FED. ROAD DIST. NO.	STATE	FED. AID PROJ. NO.	FISCAL YEAR	SHEET NO.	TOTAL SHEETS
HAWAII	HAW.	I-H3-I(61)	1990	281	424

HALAWA APPROACH

HAIKU APPROACH

DATE	REVISION
8/6/92	REVISED DOMESTIC WATER GPM AND SANITARY GPM & TANK SIZE PER DCN61-031
4/26/90	DELETED NOTE: 25 GPM FROM CONTROL BUILDING
STATE OF HAWAII DEPARTMENT OF TRANSPORTATION HIGHWAYS DIVISION WATER BALANCE DIAGRAM STANDARDS INTERSTATE ROUTE H-3 F.A.I. PROJ. NO. I-H3-I(61)	
SCALE: NONE	DATE: JAN 1990
SHEET NO. M2	OF 8 SHEETS

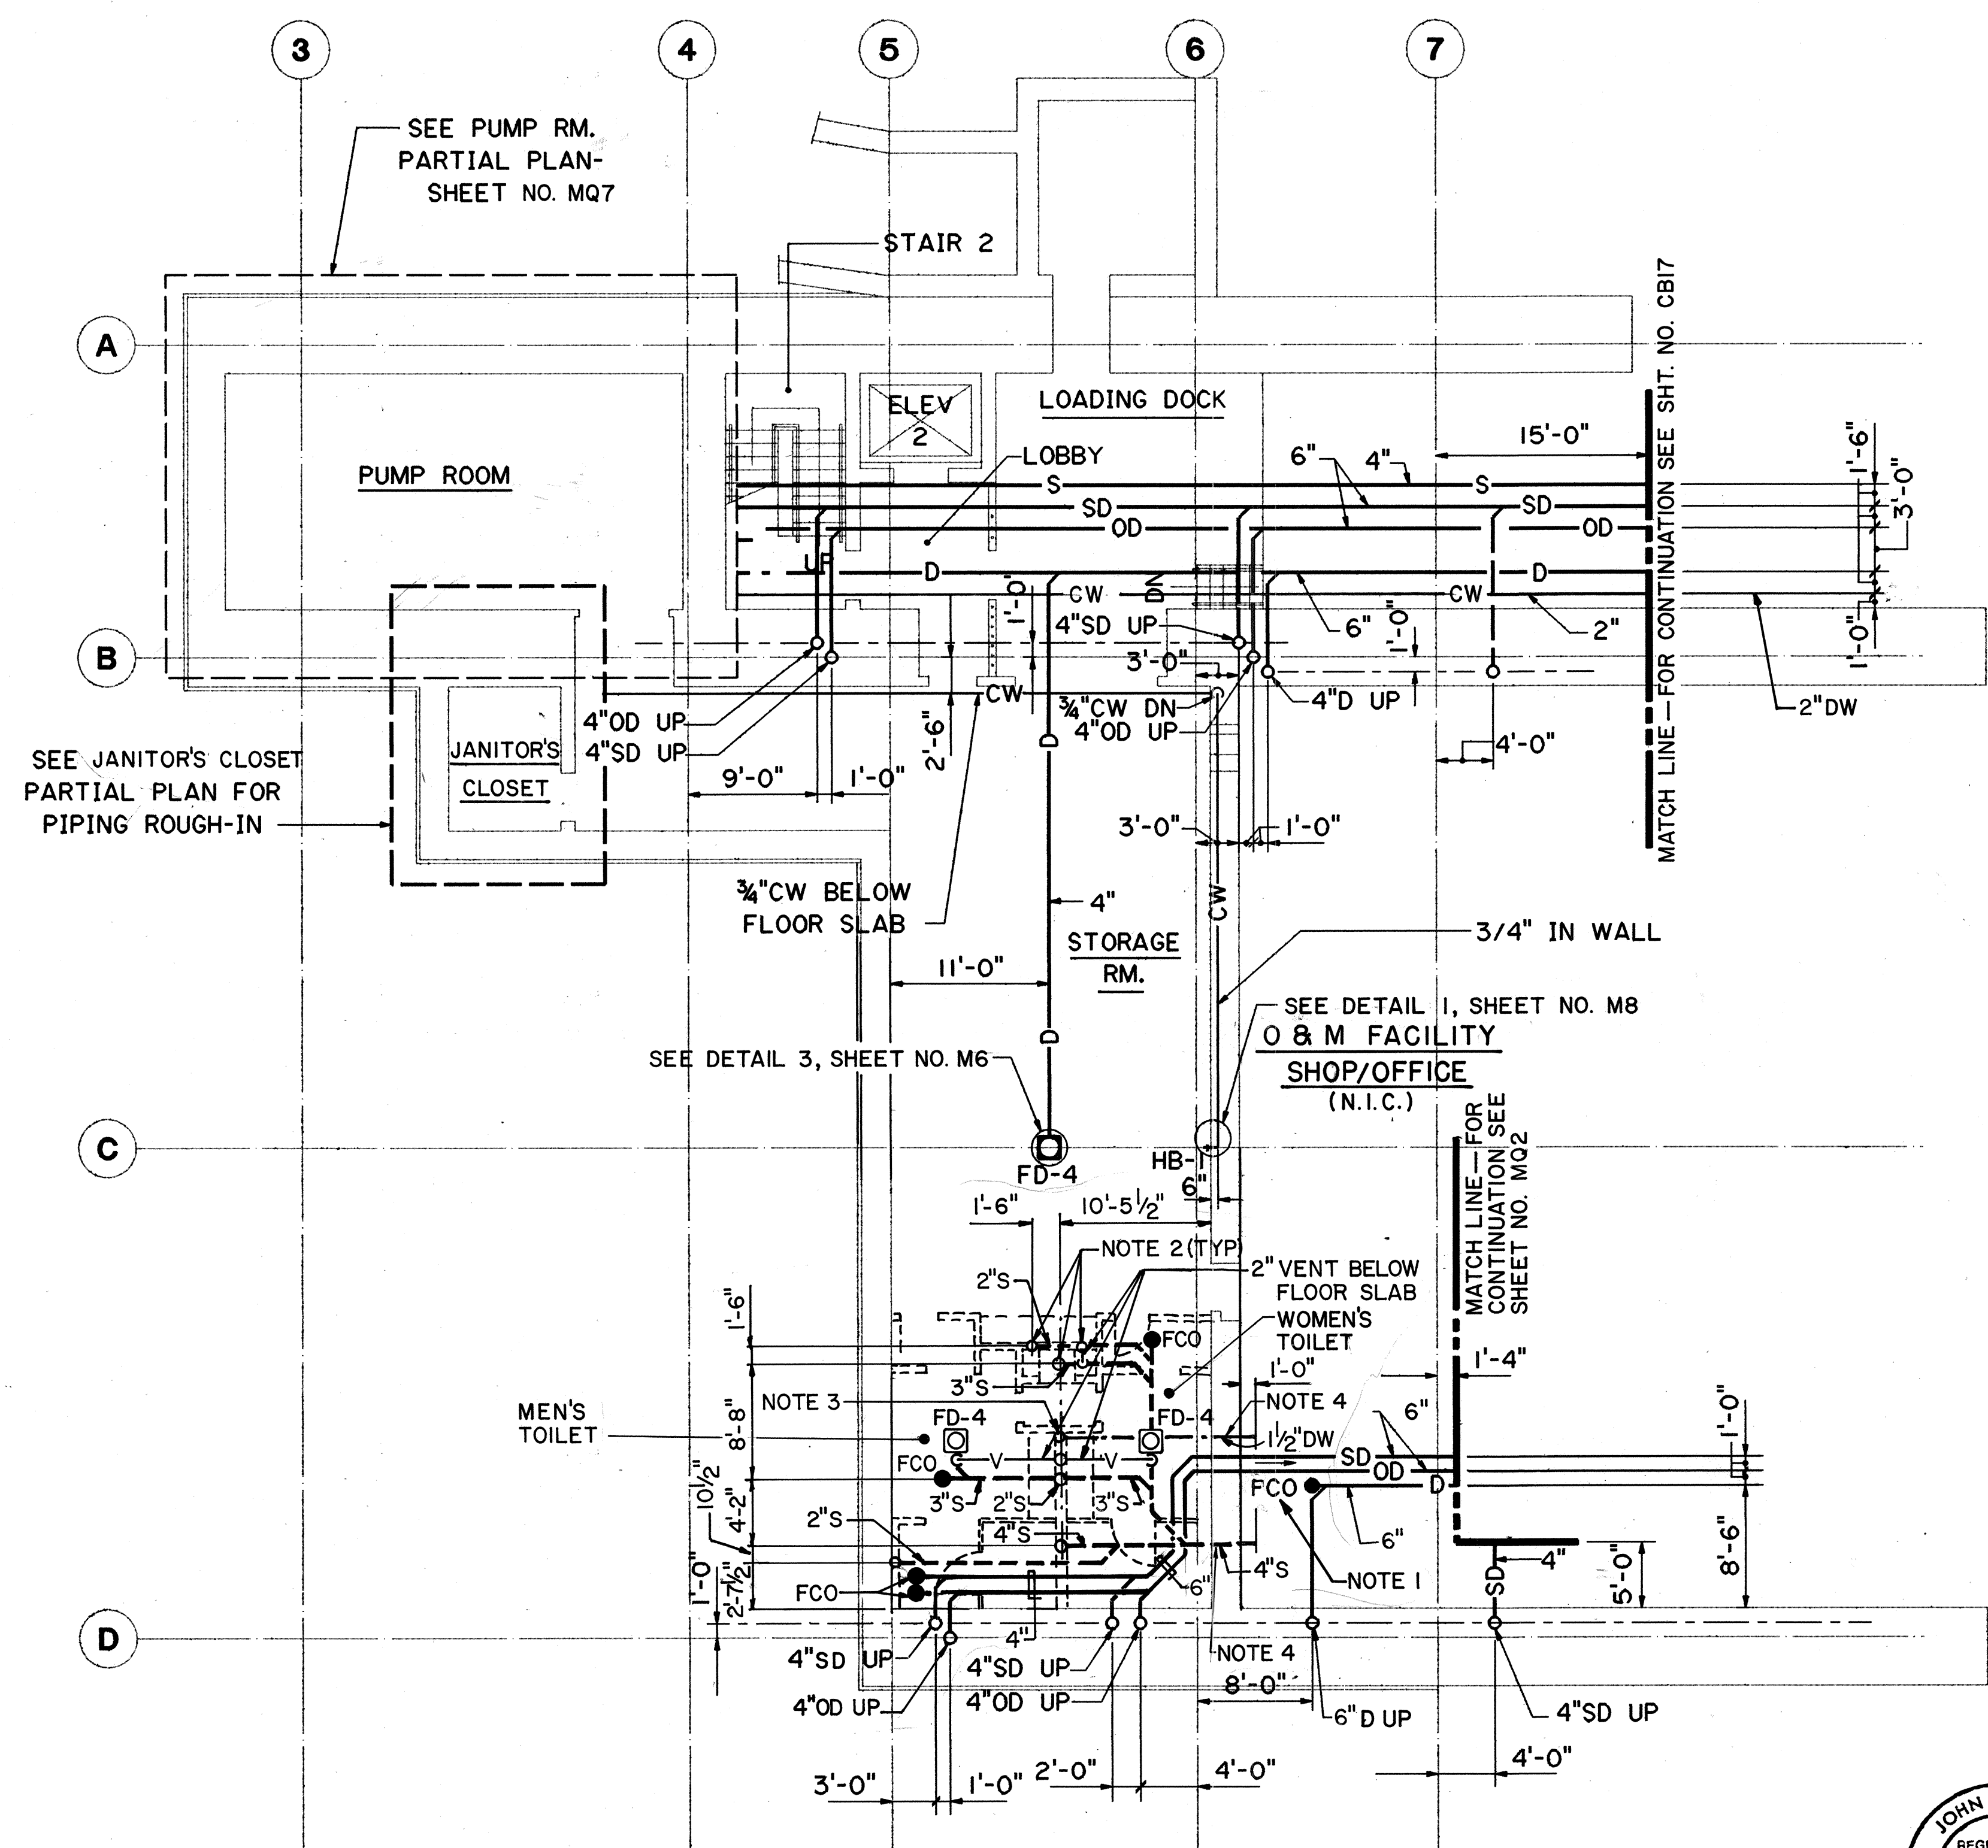
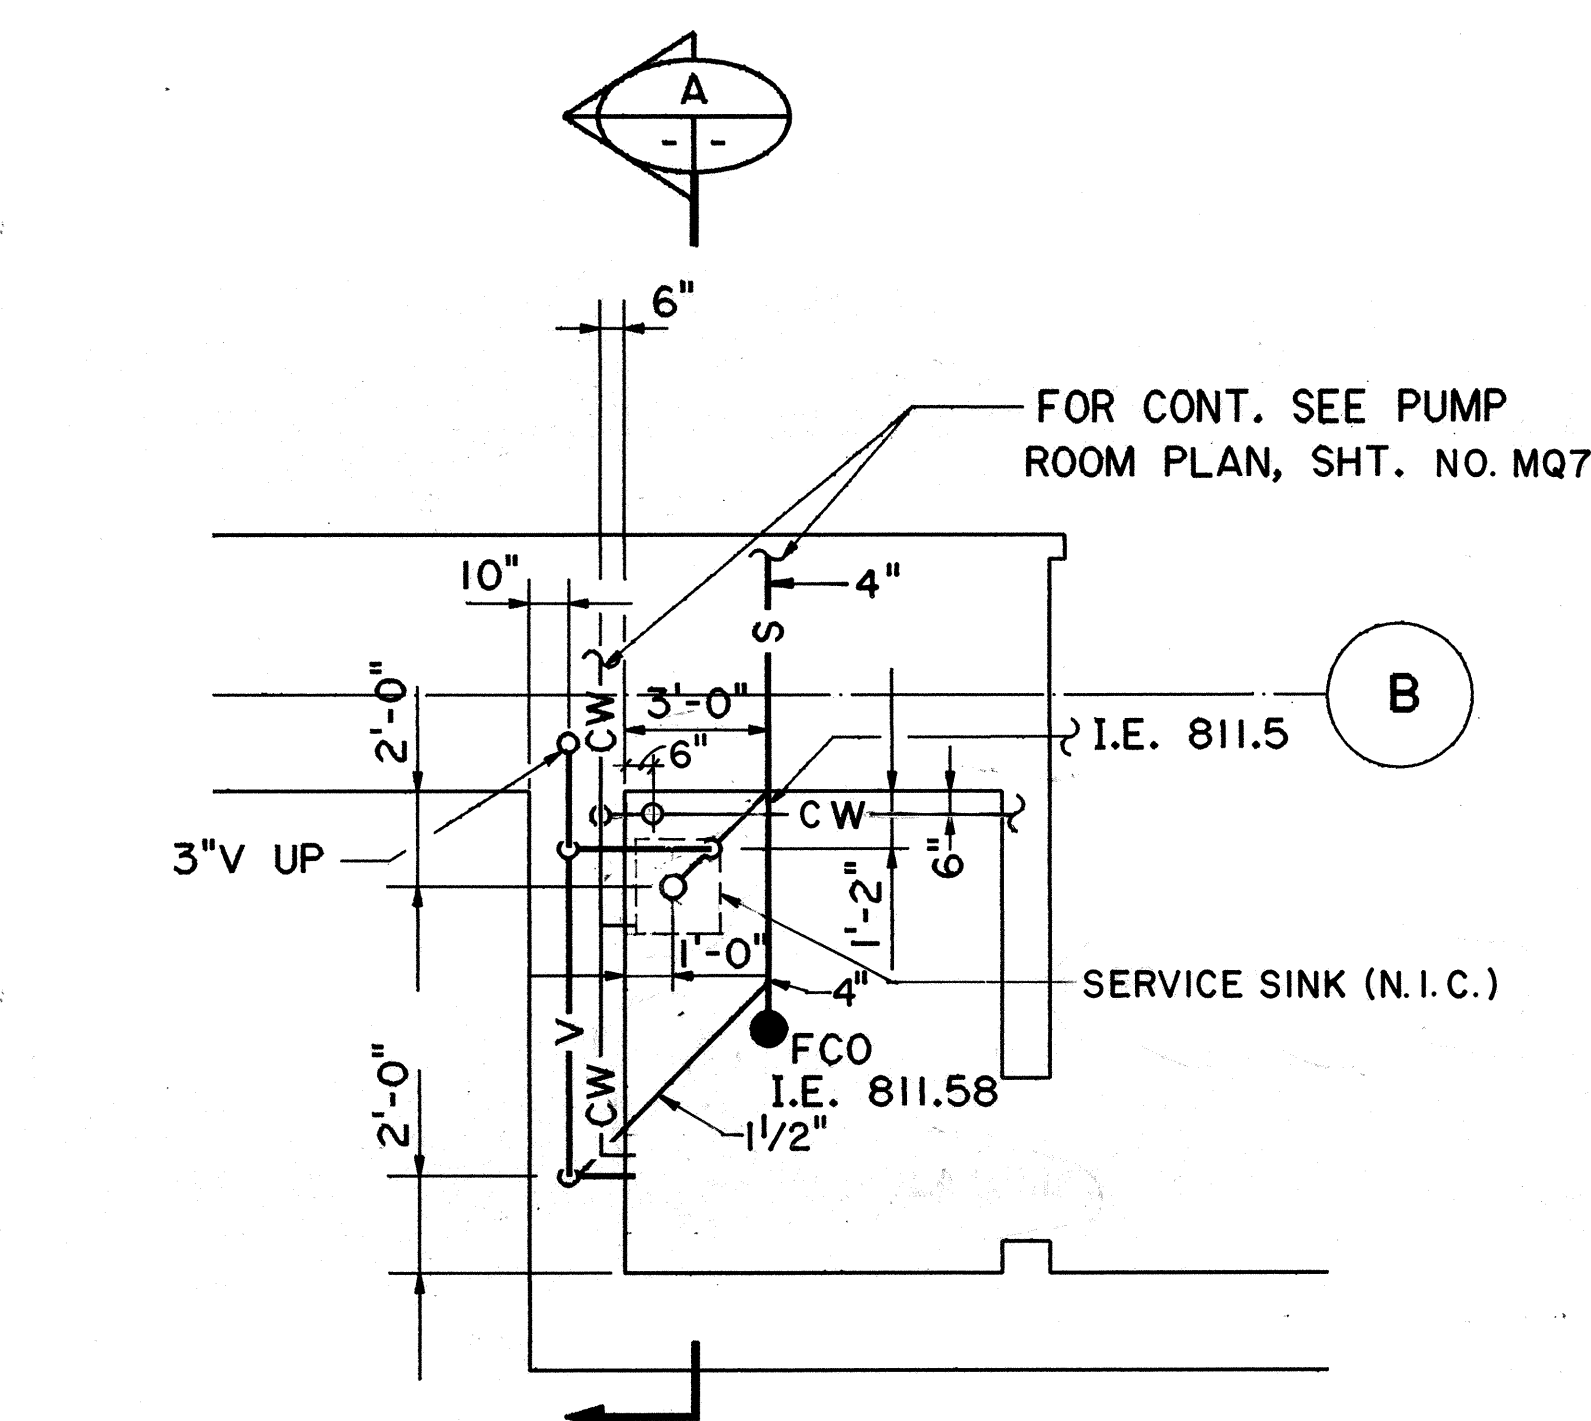
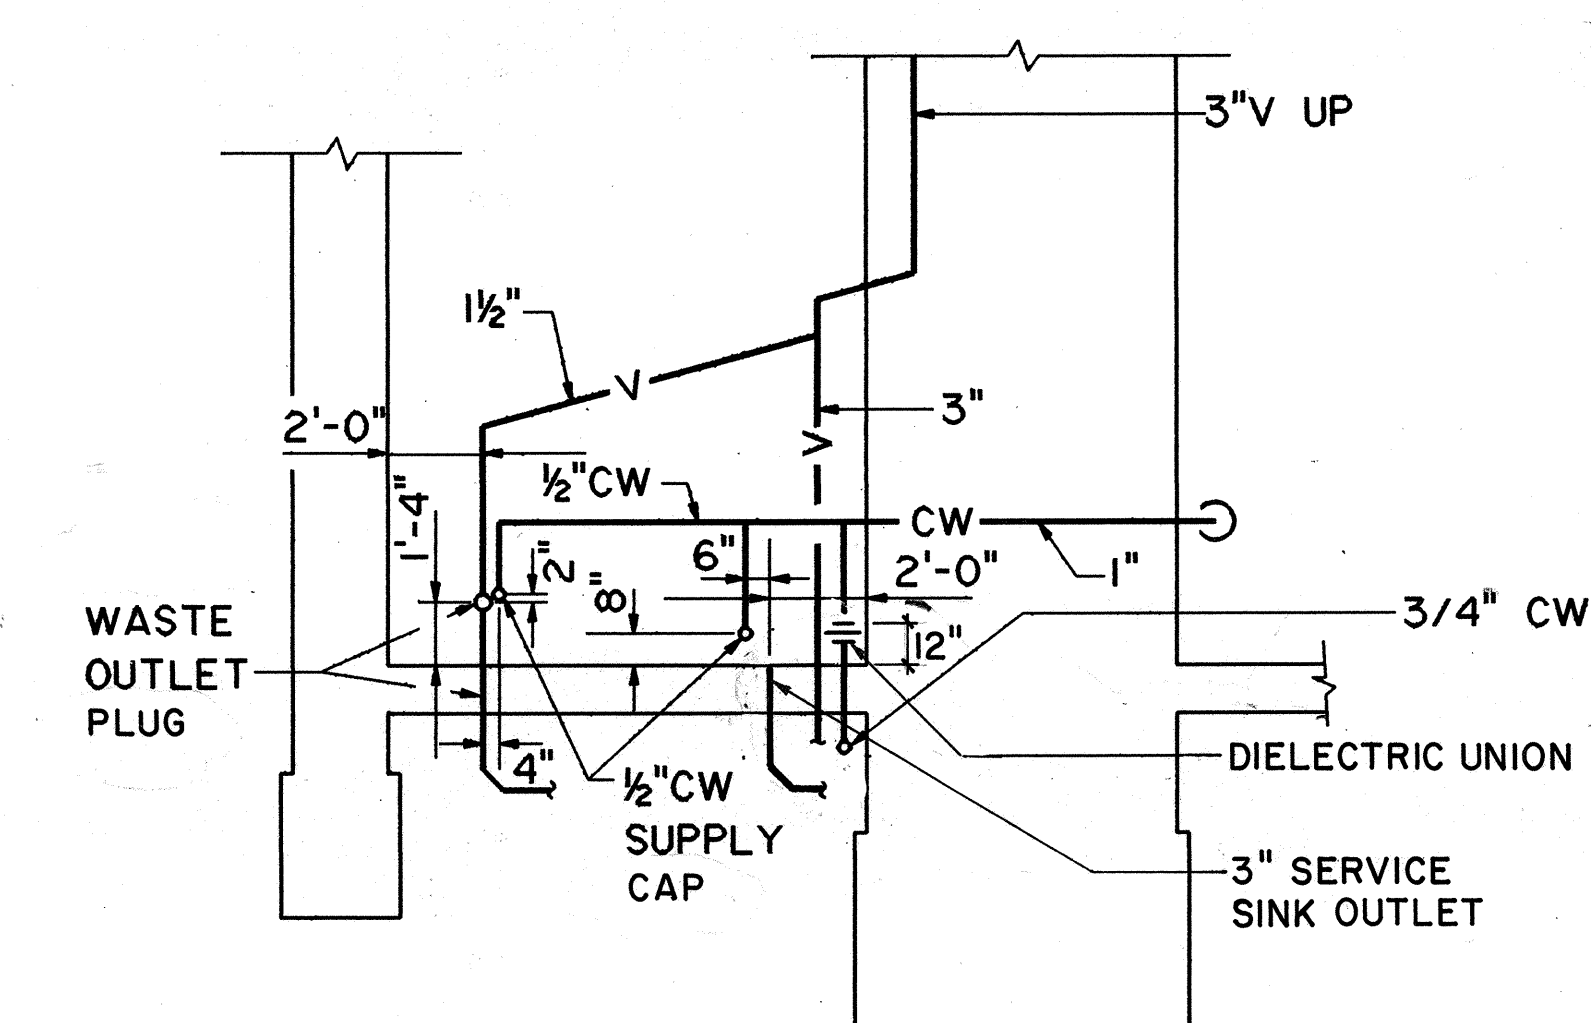
DATE	REVISION
8/6/92	ADDED PLUMBING FOR O & M TOILETS PER DCN 61-031
4/26/90	REVISED LOCATION OF WATER CLOSET MOUNTING PLATE ON SECTION A
STATE OF HAWAII DEPARTMENT OF TRANSPORTATION HIGHWAYS DIVISION PLUMBING - LEVEL A PLANS & SECTION HAIKU PORTAL BUILDING - OB INTERSTATE ROUTE H-3 F.A.I. PROJ. NO. I-H3-1(61)	
SCALE: AS NOTED	DATE: JAN 1990
SHEET NO. MQ1	OF 11 SHEETS

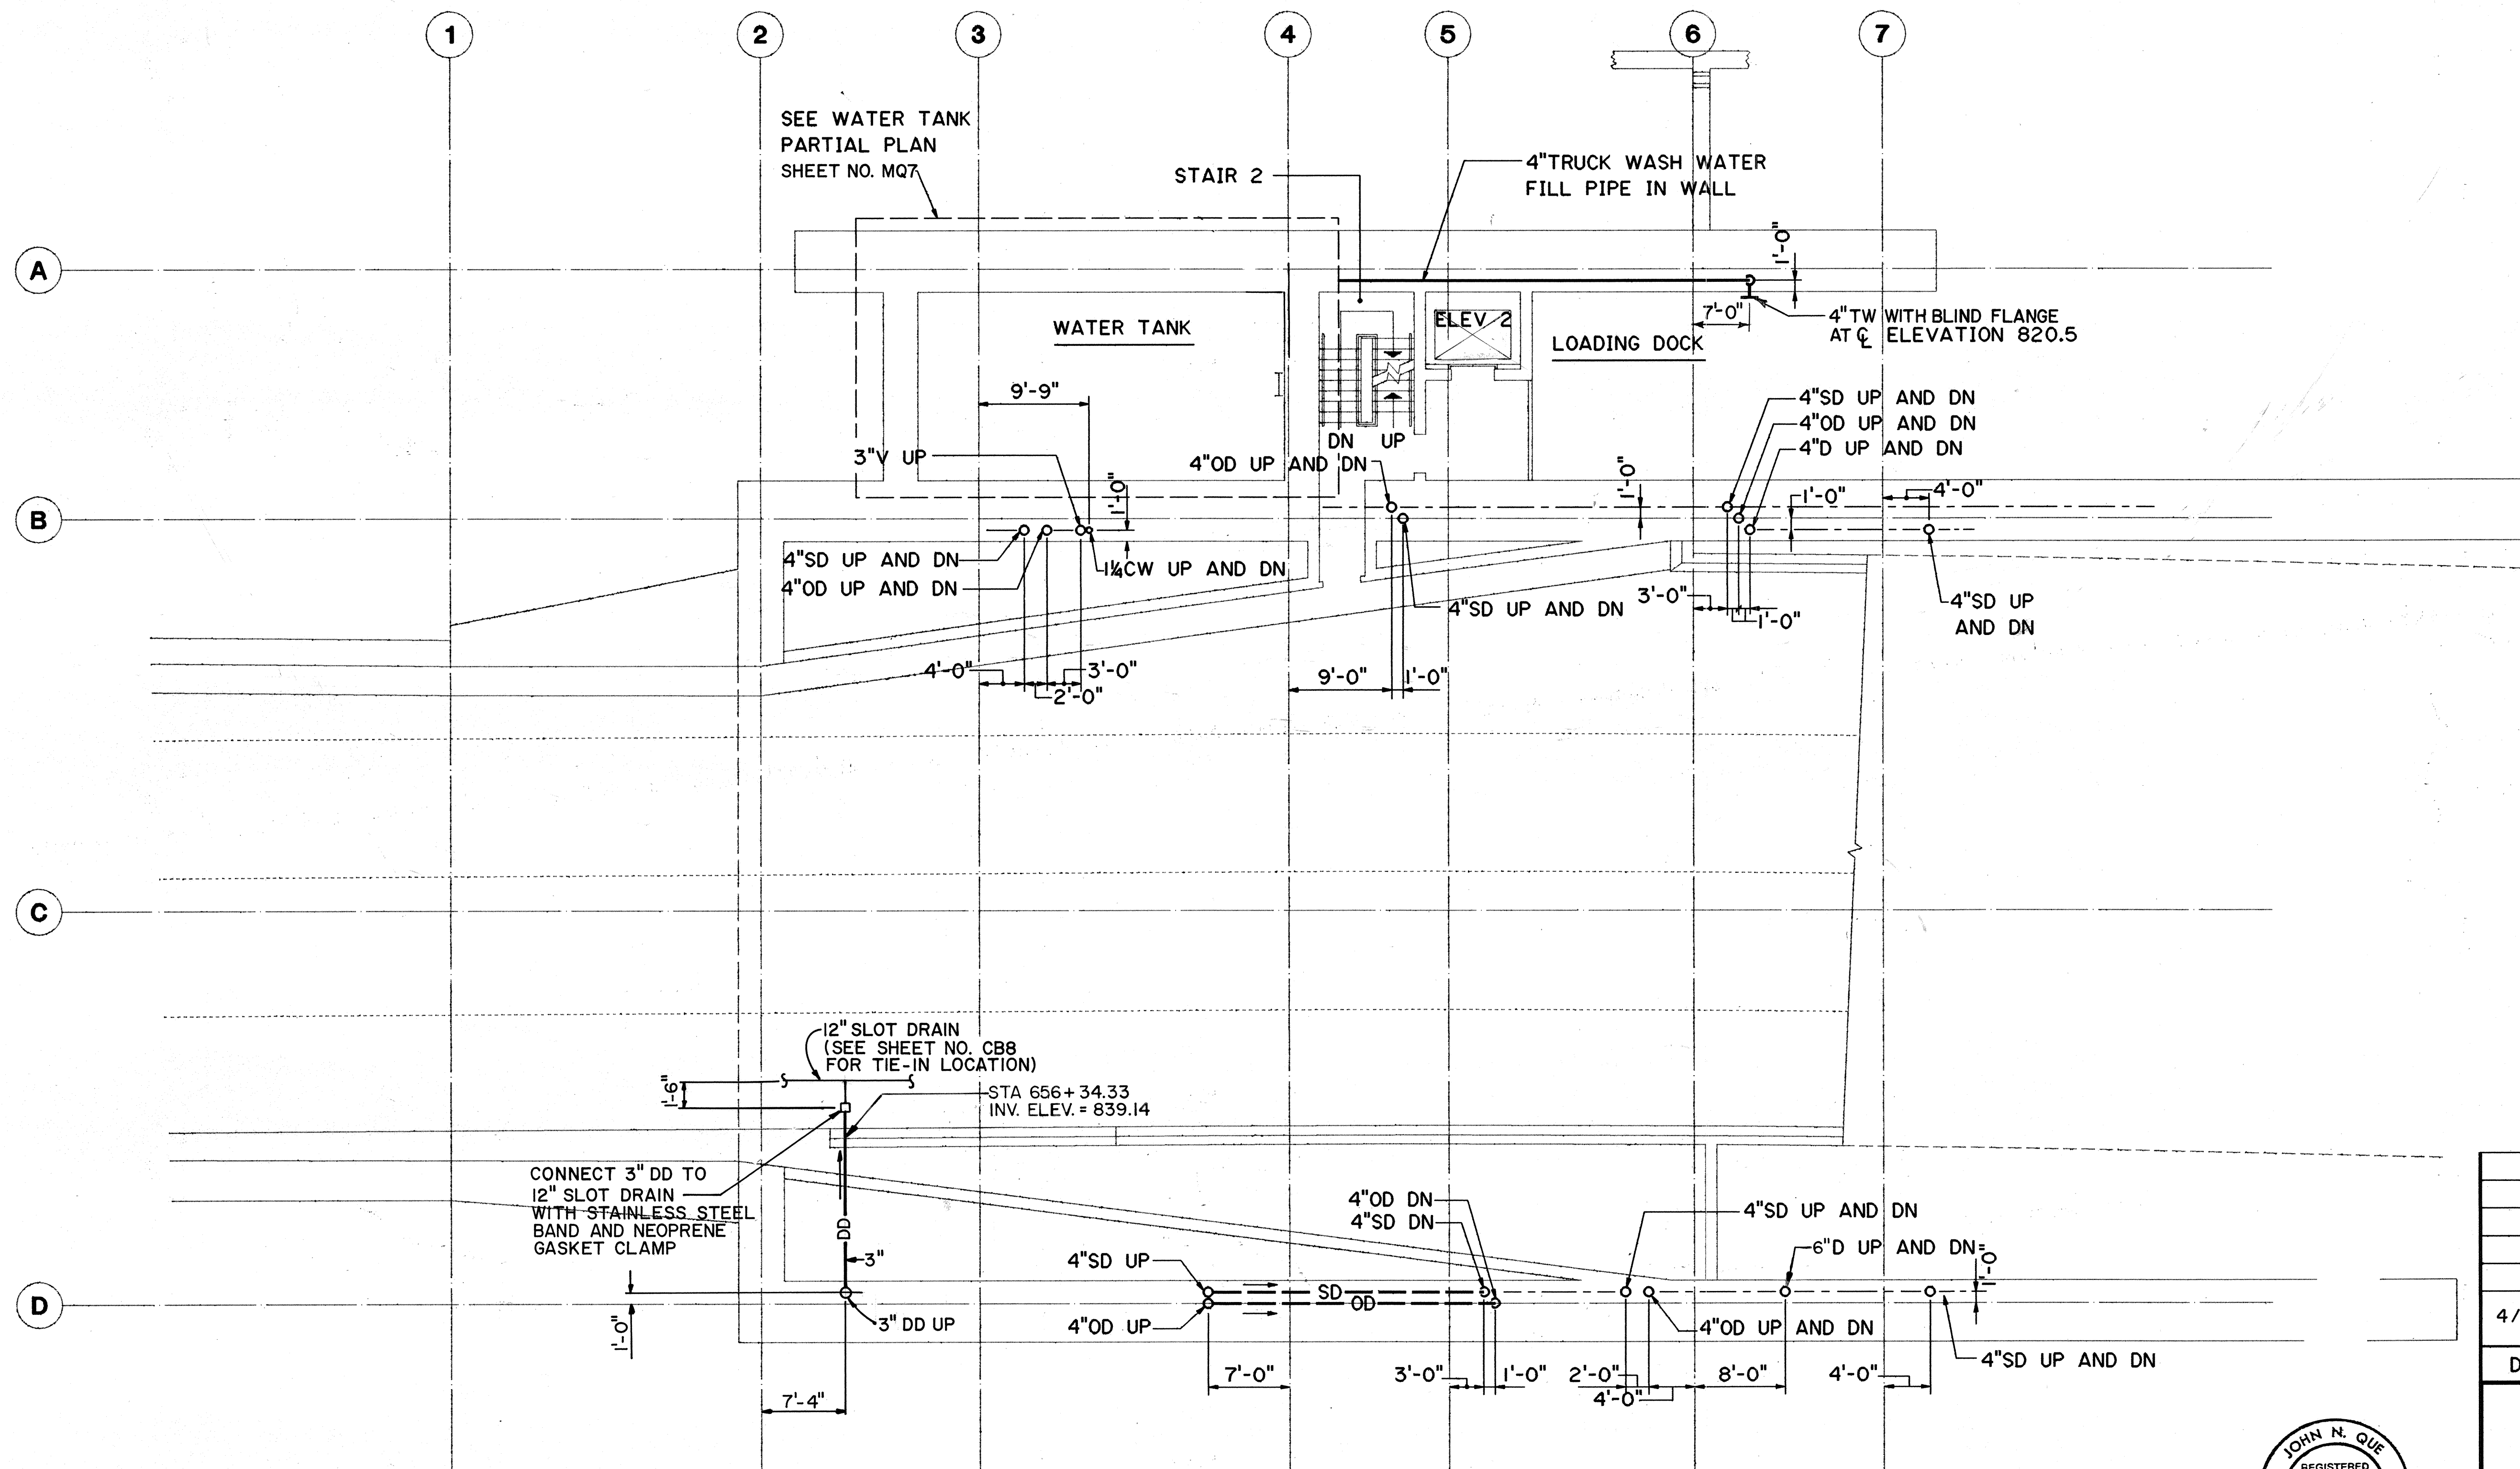
DATE	4/26/90
REVISION	DELETED BUTTERFLY VALVE AND DIMENSIONED TW STUB-OUT LOCATION
STATE OF HAWAII DEPARTMENT OF TRANSPORTATION HIGHWAYS DIVISION PLUMBING - LEVEL 1 PLAN HAIKU PORTAL BUILDING - OB INTERSTATE ROUTE H-3 F.A.I. PROJ. NO. I-H3-1(61) SCALE: 1/8"=1'-0" DATE: JAN 1990 SHEET NO. MQ2 OF 11 SHEETS
